TO: Khadeja Sarwar, Atwell, LLC
FROM: Amber Wood Hicken, Planner I
DATE: 4/9/25
SUBJECT: Parker Pointe, Black Rock Coffee, Site Plan
Review Comments 02

BLACK ROCK COFFEE BAR
 13135 DECLAN DRIVE
BLACK ROCK COFFEE BAR
 SITE PLAN

BLACK ROCK COFFEE
MODULAR BUILDING

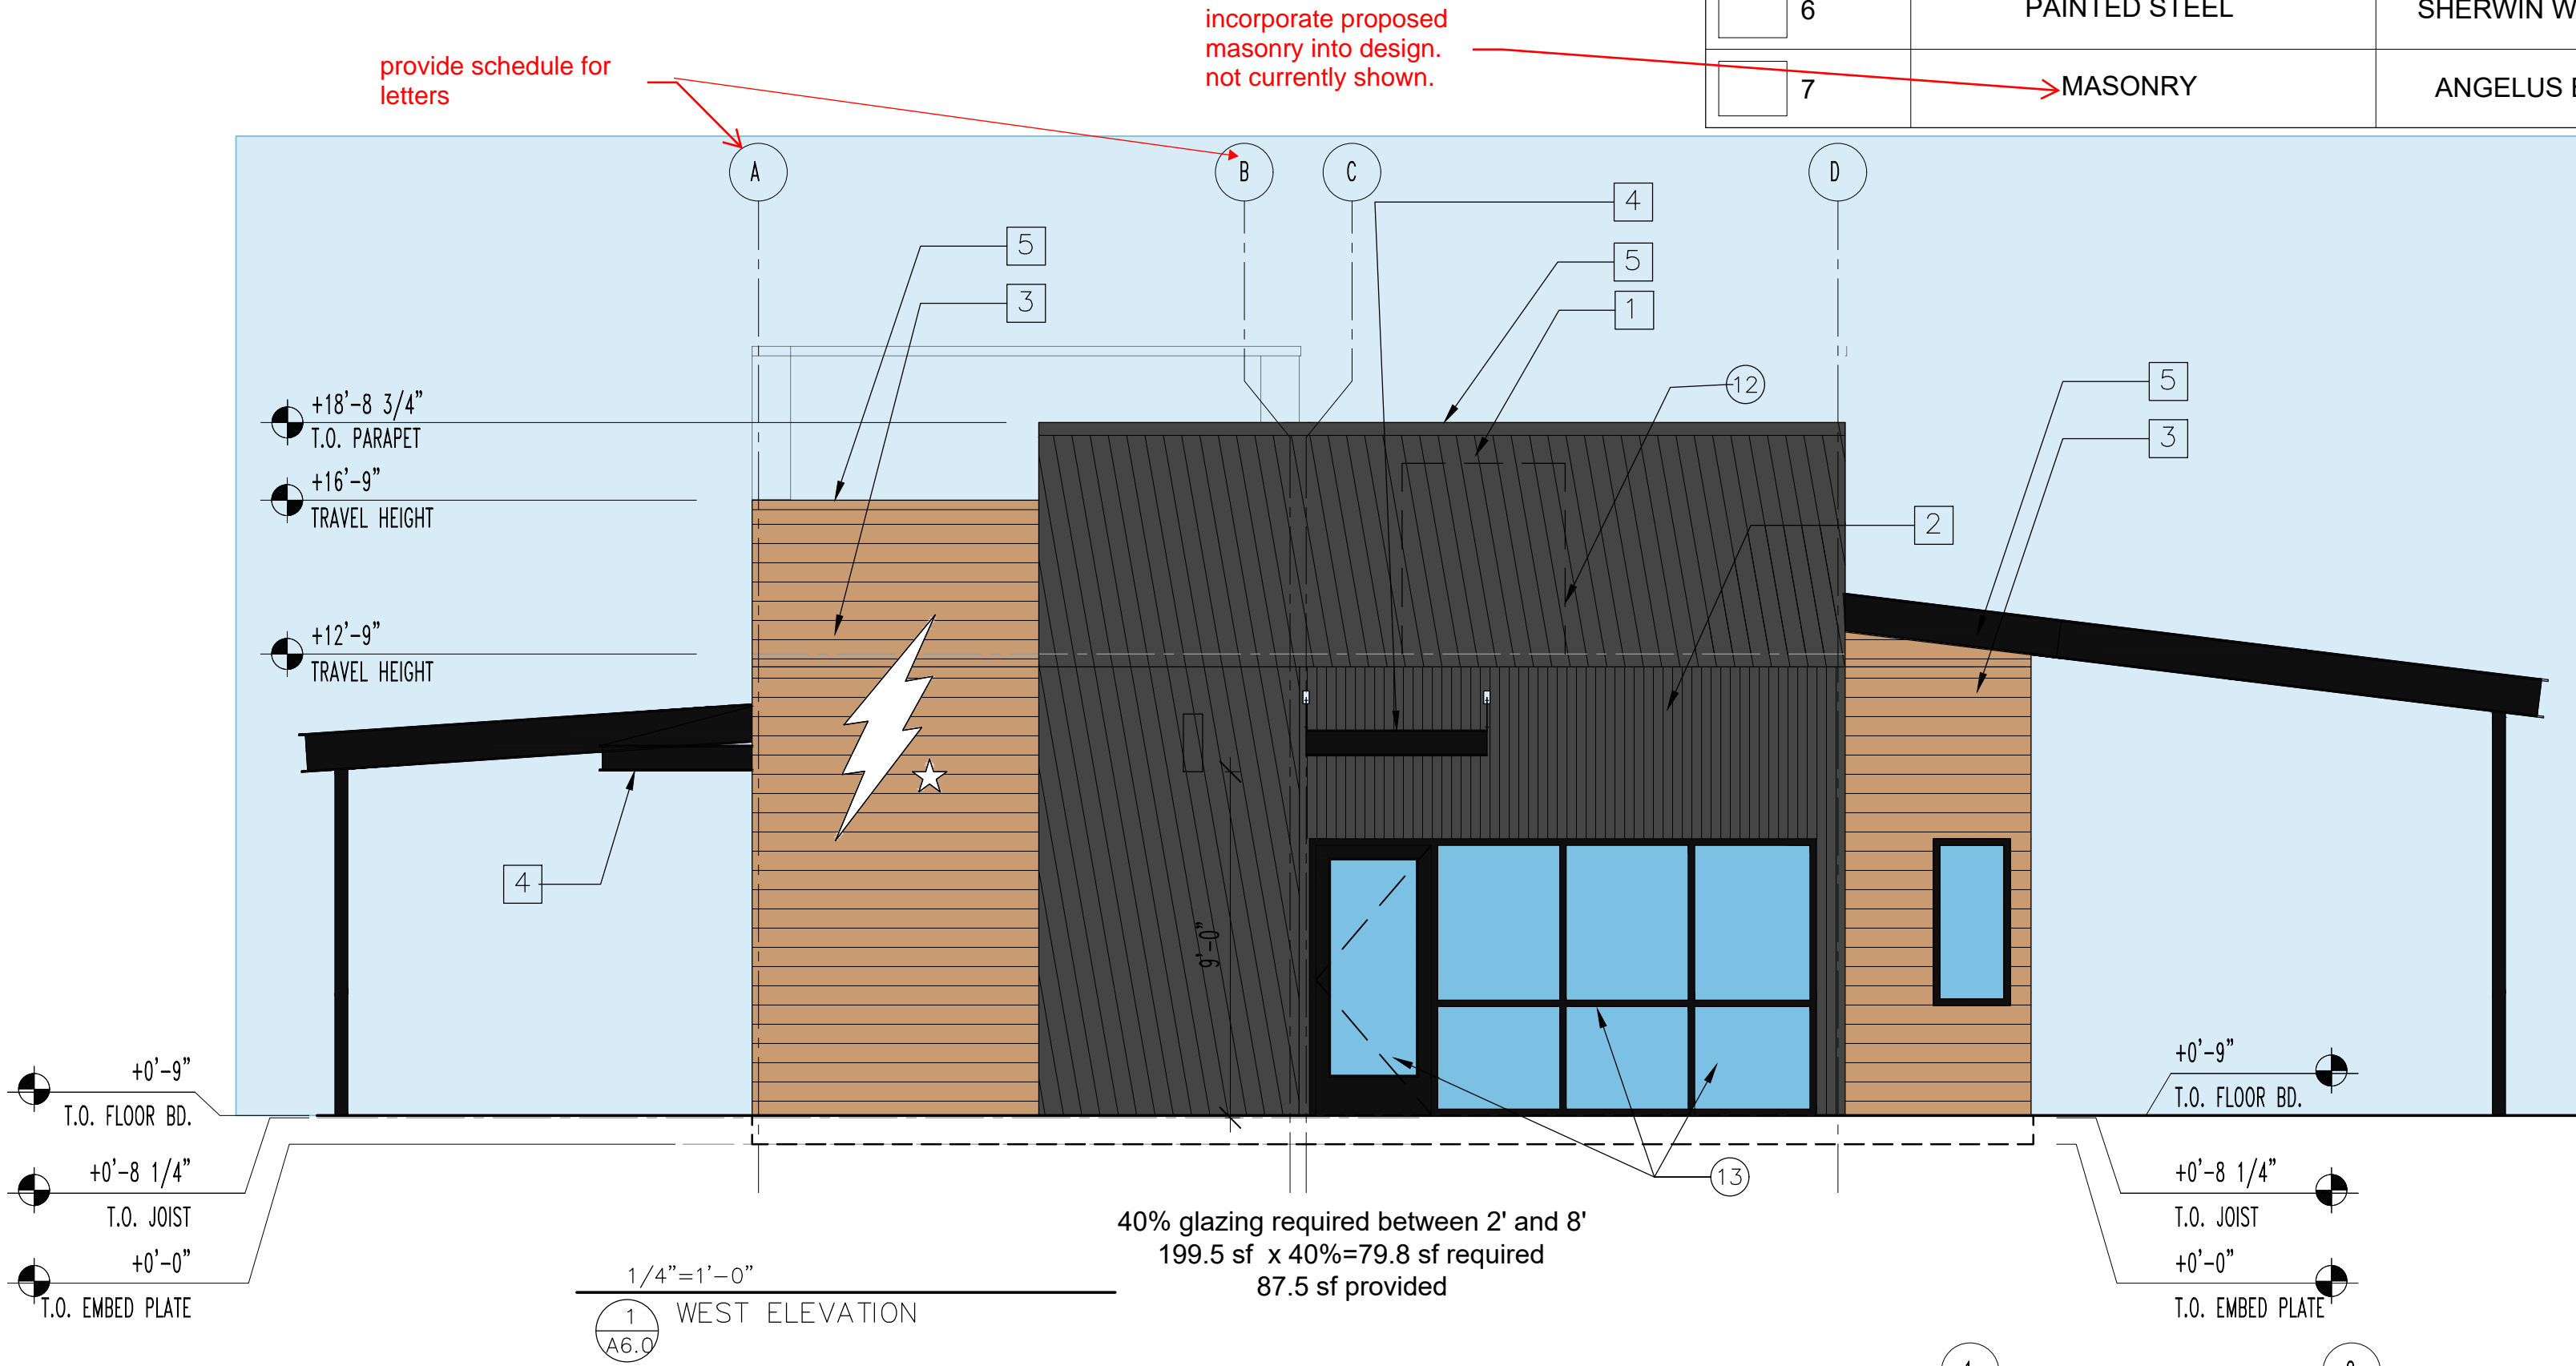
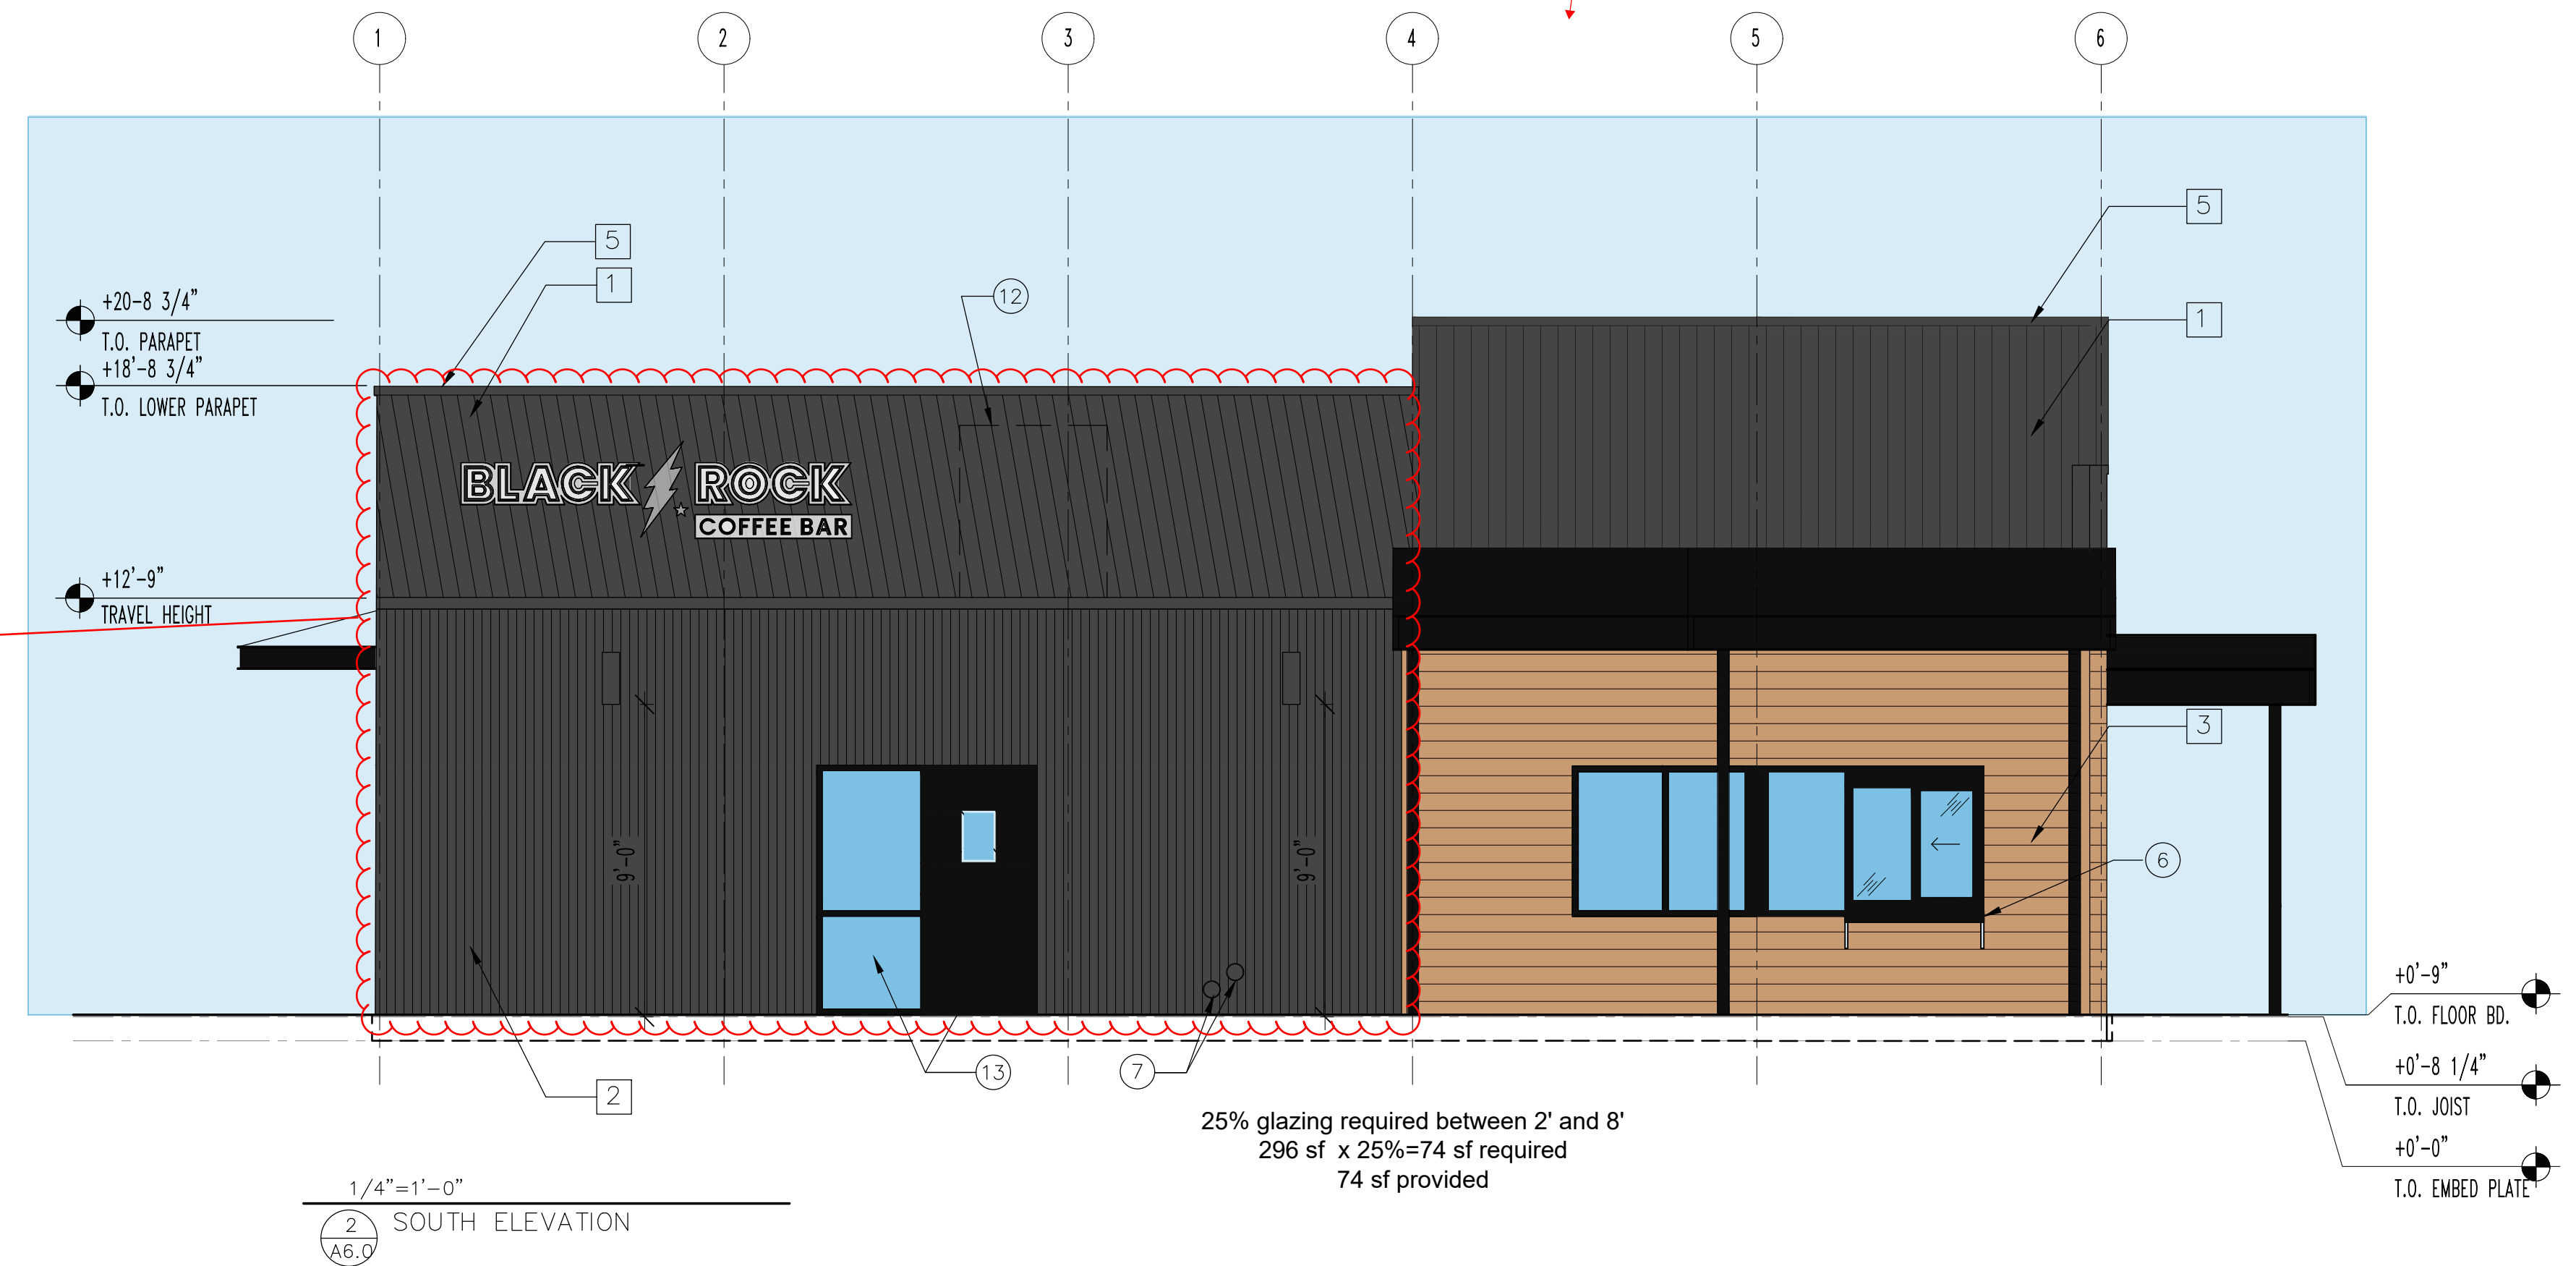
incorporate proposed masonry into design. not currently shown.

provide schedule for letters

will this be sand castle or light oak? list one

will this be charcoal gray or onyx? list one

spandrel glass is not permitted per Development Design Standards

architecture needs to be enhanced, especially on west side facing parker road. only two materials used on entire building - add more materials, possible corner feature on parker road, etc.
